Re: Proposed Plans for Garcia Mobile Home Park

Re: Garcia Mobile Home Park Drainage Report

Re: Garcia Mobile Home

**GARCIA MOBILE
HOME PARK
DRAINAGE REPORT**

SURVEY FOR MR. RAY GARCIA
SUBDIVISION MAP OF TRACTS NO. 209 AND 210
IN THE CITY OF
TRACTS ALLOTTED FROM THE TOWN OF ATRISCO GRANT
IN SANTIAGO COUNTY, NEW MEXICO
CORRECTOR PLACE SW
SUNSET GARDENS ROAD S.W.
SALVADOR ROAD S.W.

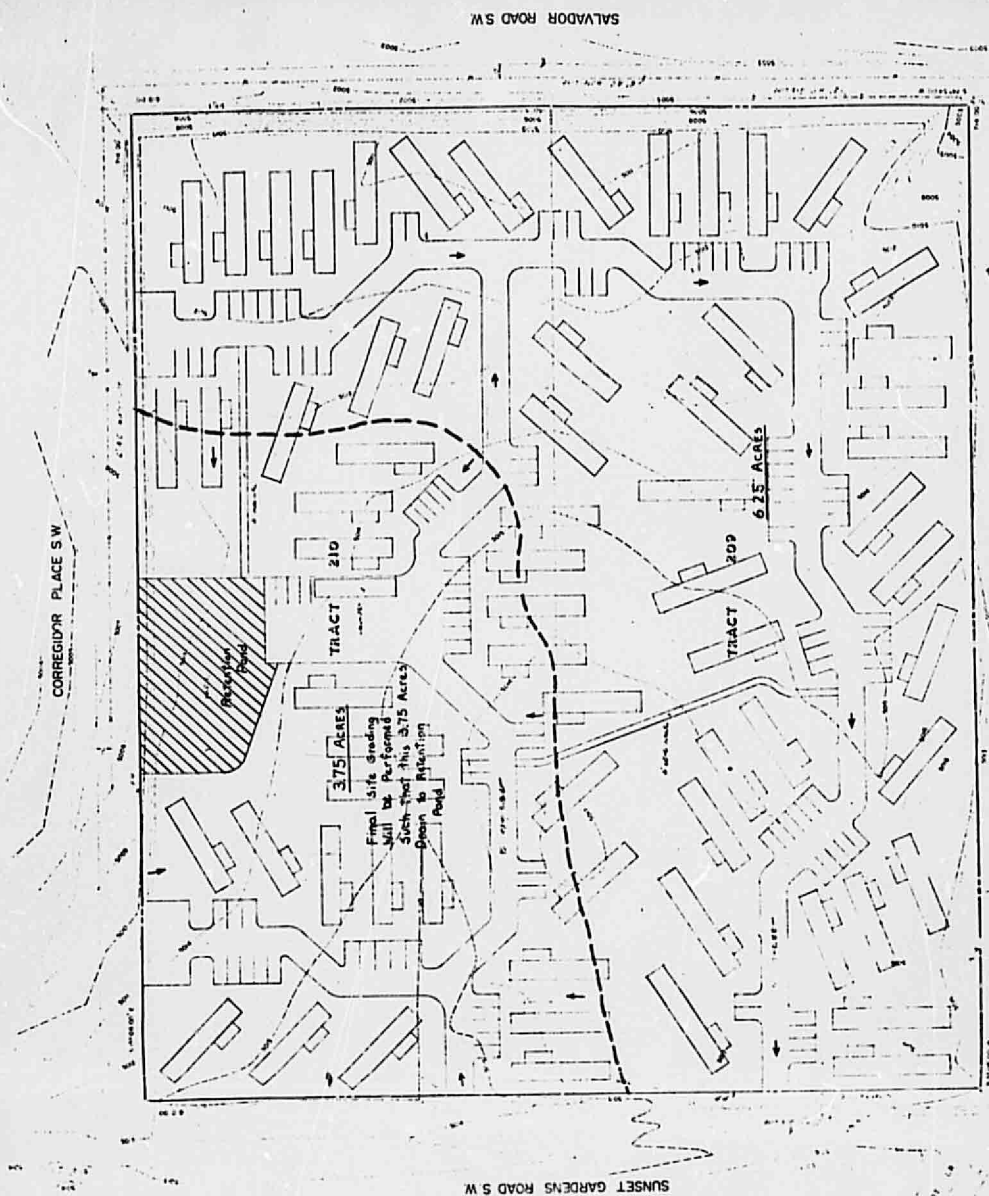
about a year and a half ago we received a
complaint from the owner of lot 203 that the
owner of lot 209 & 210 was bringing in concrete
rubble & dirt on his lots into a friendly neighbor hood
In so doing he obliterated the natural ponding areas
(See attached aerial photo) and now the water from
Sunset Garden a Corridor must go down the hill
What is the ordinance or policy that is most appropriate
to this case?
